**Subject:** Exhibition – Planning Proposal Mt Gilead Stage 2

### Attachment 1 – EHG comments on exhibited Mt Gilead Stage 2 planning proposal

### **App C – Mt Gilead Stage 2 Biodiversity Certification Assessment Report and Strategy dated November 2022 (version 7)**

Figure 7: The separation of the vegetated buffer (which can include koala feed and shelter trees, with a bias towards the area adjacent to the corridor) and APZ

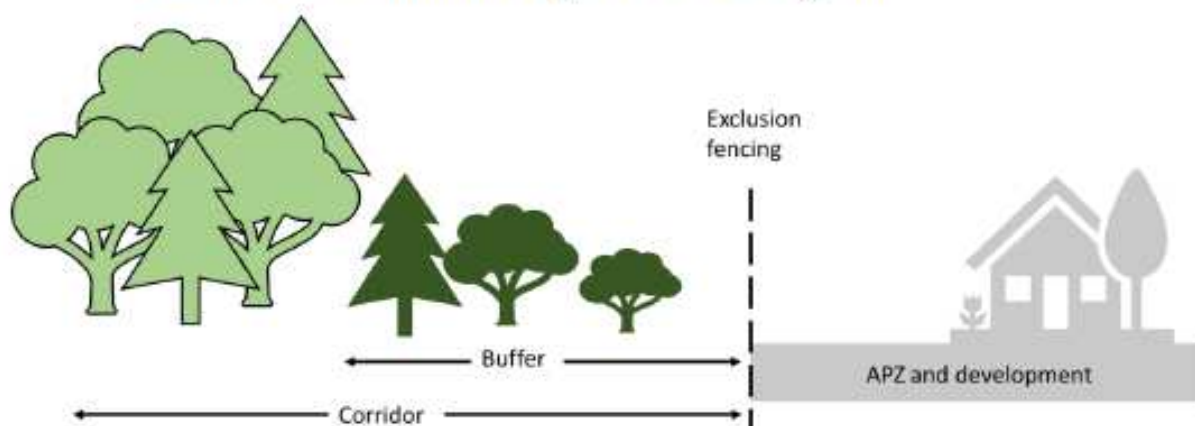
It is important to acknowledge that if these activities should not be included within the buffers, then clearly, they should not be included within the primary Koala corridors.

*should be doubled from 15m in Figure 6 to 30 m in Figure 9.*

Map 1 – Figure 4 Biodiversity Certification Assessment Report and Strategy

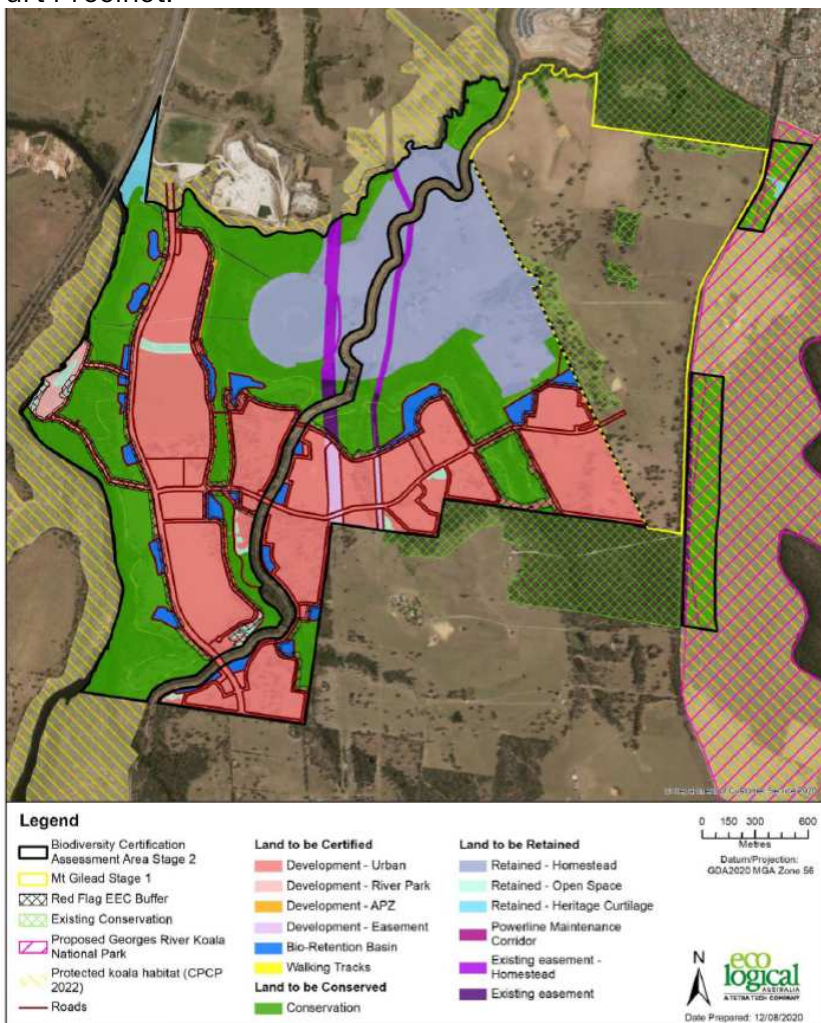
In response to the recommendations of the OCSE, the Biodiversity Certification Assessment Report and Strategy includes Figures 4 and 5 (maps 1 and 2 below) which depict several uses of land within the Koala corridors that are inconsistent with the OCSE recommendations including the Riverside Reserve, basins and asset protection zones (APZ).

Regarding the **Riverside Reserve**, the Biodiversity Certification Assessment Report and Strategy Figure 4 identifies the reserve and its access roads within the Koala corridor as ‘Land to be Certified Development – River Park’. The report also refers to the river park as “open space” and states that (p 112) *A one-way access road will link the urban area to this river frontage but will not impact riparian buffers, the area will be fully landscaped with picnic/BBQ areas and car parking.* Based on the advice provided by the OCSE including Table 1 above, the proposed Riverside Reserve including the picnic areas and access roads should not be included within the Nepean River Koala corridor. It is clear that the Riverside Reserve and its access roads are part of the proposed urban development land and not part of ‘land to be conserved’. The proposed clearing of Koala habitat to facilitate the reserve and its access roads is therefore not supported by EHG.

The proposed Riverside Reserve and its access roads are also inconsistent with the Gilead Stage 2 Technical Assurance Panel (TAP) advice. In addition, it is not included in the proposed Gilead Biodiversity Stewardship Agreement (BSA) site and therefore is not included in the conservation outcome for the site. It is also important to note that the Cumberland Plain Conservation Plan (CPCP) does not include certified areas for open space and parks within the Koala corridors in the Appin Part Precinct. Therefore, EHG believes the proposal to certify the Riverside Reserve and its access roads within the Koala corridor is inconsistent with the approach to conservation of Koala corridors in the CPCP in the Appin Part Precinct.

## Map 2 – Figure 5 Biodiversity Certification Assessment Report and Strategy

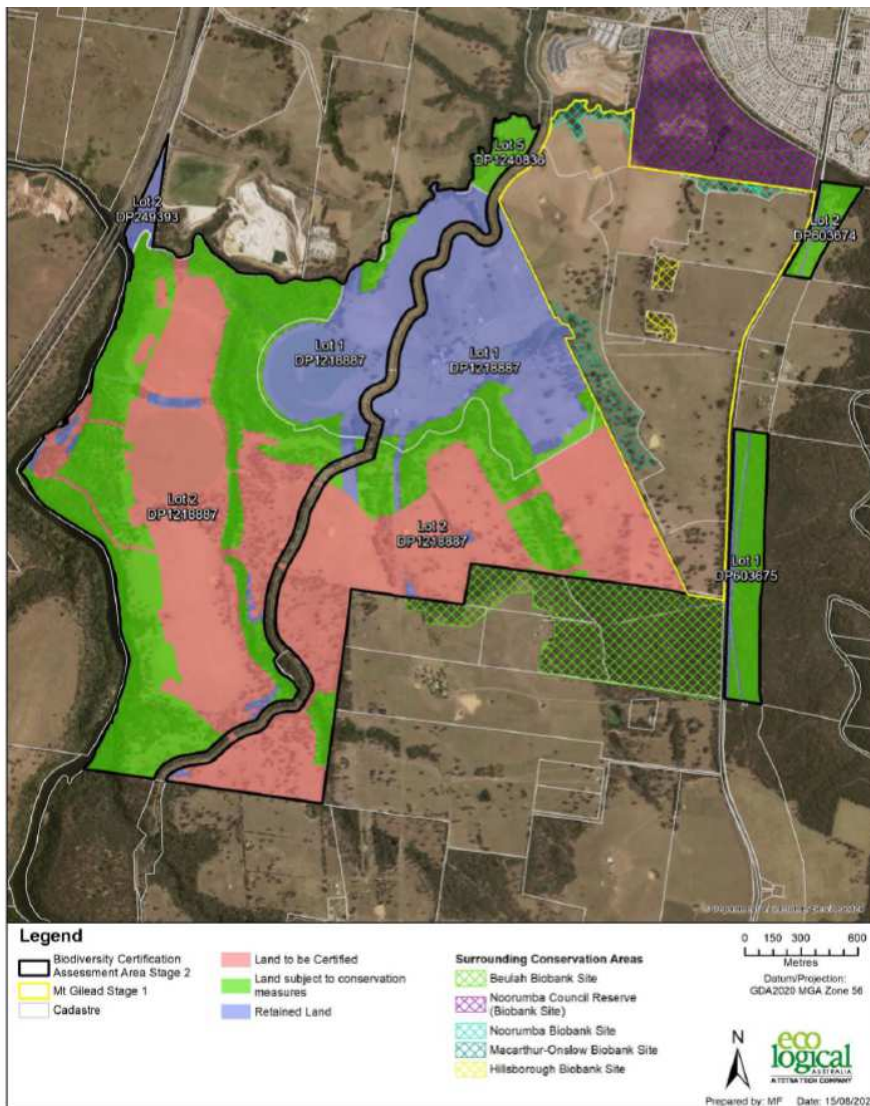
EHG raises concerns that the **Koala corridor boundaries and location of buffers** as per the OCSE requirements have not been identified on maps. EHG notes there are areas where the corridor boundary line cuts off existing Koala habitat resulting in part of the existing habitat being located within the Land to be Certified. As stated by the OCSE:

Therefore, the Koala corridor boundaries should be revised to ensure that existing habitat that forms part of the corridor is conserved and not severed/cleared through their inclusion in the

proposed certified area. The Biodiversity Certification Assessment Report and Strategy maps should also include the corridor width measurements and the location of the buffers as recommended by the OCSE.

Figure 4

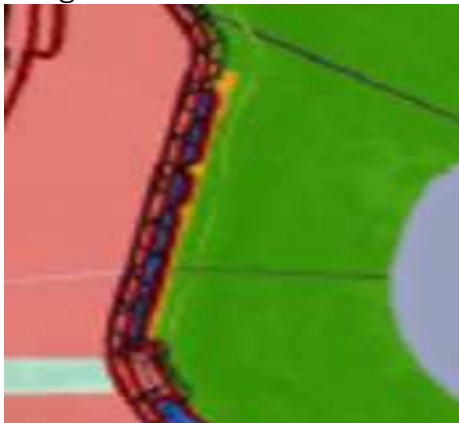
Regarding **APZs**, as depicted in Figures 4 and 16 (see excerpts below), it appears that part of the APZ is located within the Koala corridor and is identified as 'Land to be Certified Development-APZ' which is inconsistent with the OCSE recommendations and not supported by EHG.
